Access Compliance Report

Public Rights-of-Way

(Curb Ramps)

Intersection ID: 47834	Main Street: ALVARADO_WY	Cross Street: CAMP_VERDE_LN	Location: W
ADA ID: 6C3F2B4BD5B0	Ramp Type: PerpDiag	Initial Pass/Fail: Fail	Overall Compliance: No
Severity Score: 33.75			
Codes/Mitigation Info/Possible Solution		Field Measurements/Component Compliance

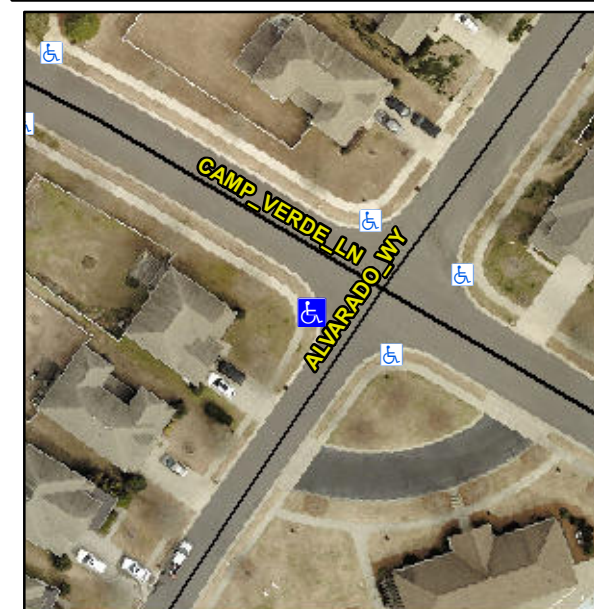
Not Found, R304.5.1, R304.5.3

Compliance	Description	Data	Compliance	Description	Data
N/A	Ramp Length (in)	132.0	Yes	Ramp Slope (%)	5.7
No	Ramp Width (in)	47.0	No	Ramp XSlope (%)	9.3
N/A	Flare Type LT	N/A	N/A	Flare Type RT	N/A
N/A	Flare Slope LT (%)	N/A	N/A	Flare Slope RT (%)	N/A
N/A	Flare Traversable LT?	N/A	N/A	Flare Traversable RT?	N/A
N/A	Landing Length (in)	N/A	N/A	DWS Provided?	N/A
N/A	Landing Width (in)	N/A	N/A	DWS Contrast?	N/A
N/A	Landing Slope (%)	N/A	N/A	DWS Length (in)	N/A
N/A	Landing X Slope (%)	N/A	N/A	DWS Full Width?	N/A
N/A	Landing Curb? (Y/N)	N/A	N/A	DWS Offset (in)	N/A
N/A	Shared Landing?	N/A			
N/A	Gutter Ponding?	N/A	N/A	Gutter Slope (%)	N/A
N/A	Gutter Lip Ht (in)	N/A	N/A	Gutter X Slope (%)	N/A
N/A	Painted X Walk1?	No	N/A	Painted X Walk2?	No
	X Walk 1 Direction	To SE		X Walk 2 Direction	To NE
N/A	X Walk 1 Width (in)	N/A	N/A	X Walk 2 Width (in)	N/A
	X Walk 1 Slope (%)	4.4		X Walk 2 Slope (%)	1.1
	X Walk 1 X Slope (%)	2.9		X Walk 2 X Slope (%)	4.7

Remove & Replace Curb Ramp With Two New Directional Ramps or Equivalent.
